# VERMONT YANKEE NUCLEAR POWER CORPORATION

Subject: Supplementary Information in Support of Proposed Change No. 98  
Reload Licensing Submittal

Yankee Atomic Boiling Water Reactor Analysis Methods: Analysis of a Typical  
BWR/4 Turbine Trip Without Bypass Transient, YAEC - 1280, October 1981.

ERRATA

Figure 2.3  
COMPARISON OF SIMULATE AXIAL POWER DISTRIBUTION  
(WITHOUT ADDED THERMAL ABSORBER) TO GE AND BNL  
DISTRIBUTIONS

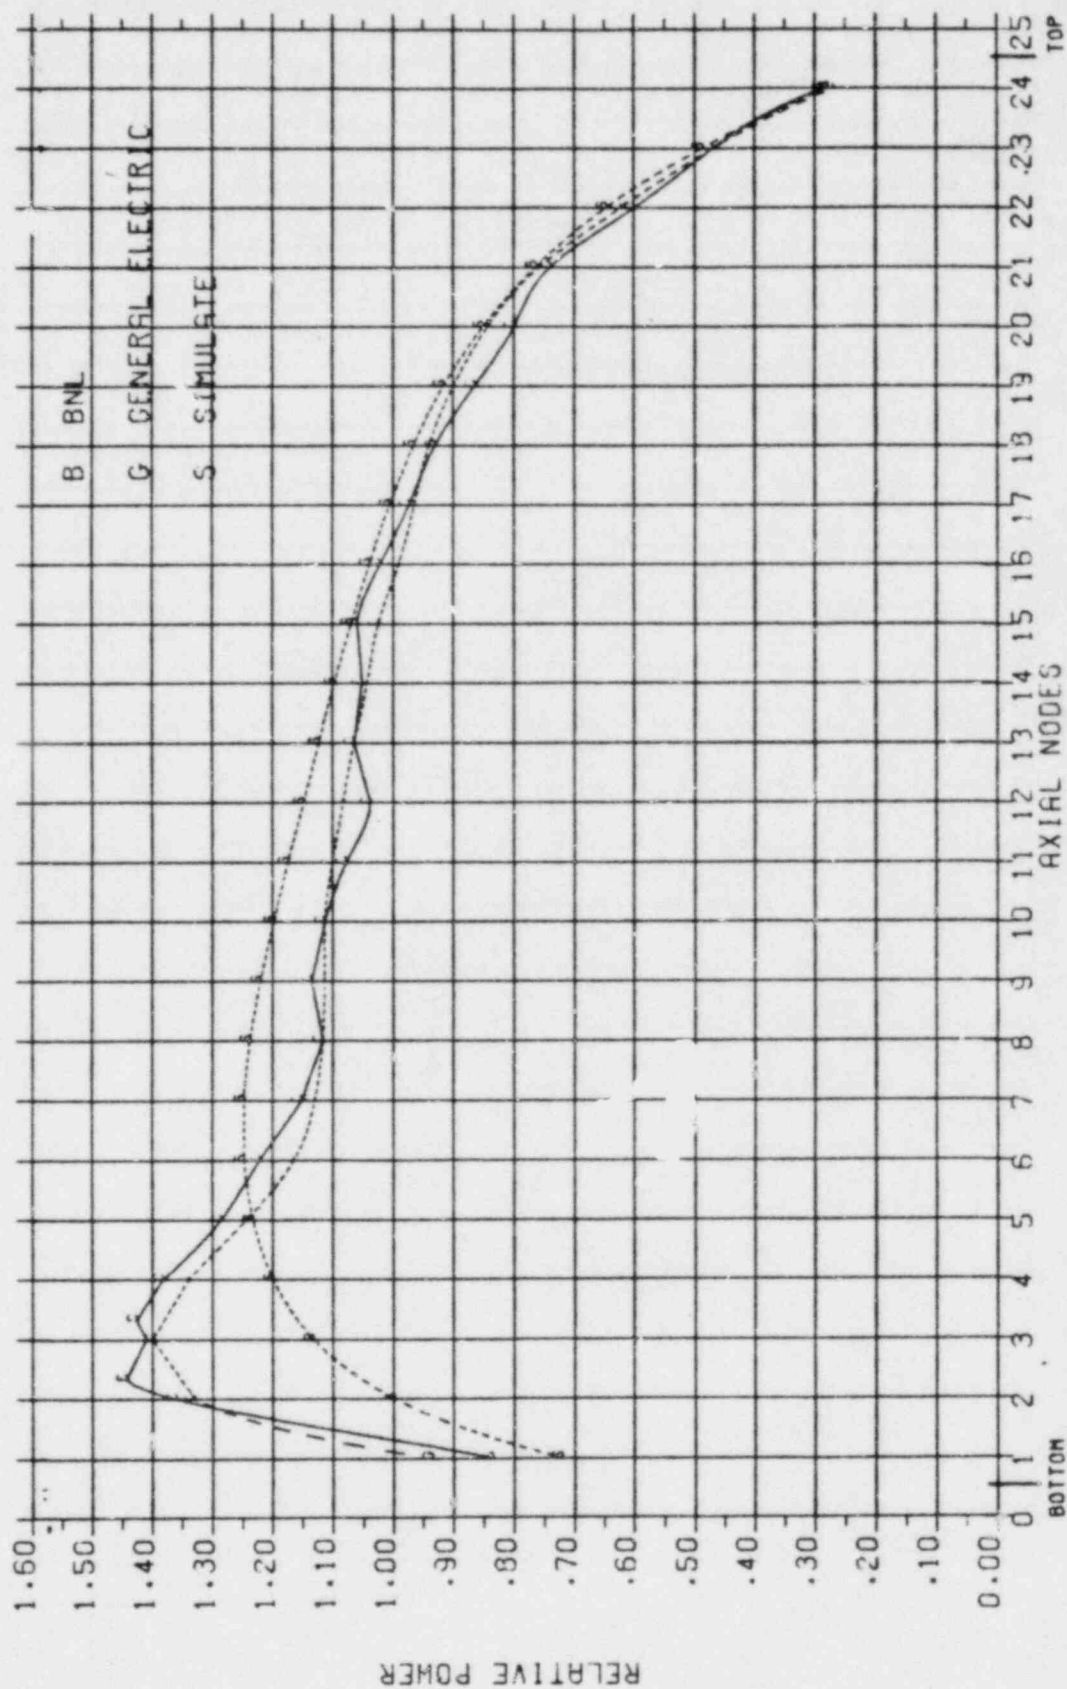
- 9      The figure should be replaced with the attached figure 2.3.
- 11     The figure should be replaced with the attached figure 2.5.
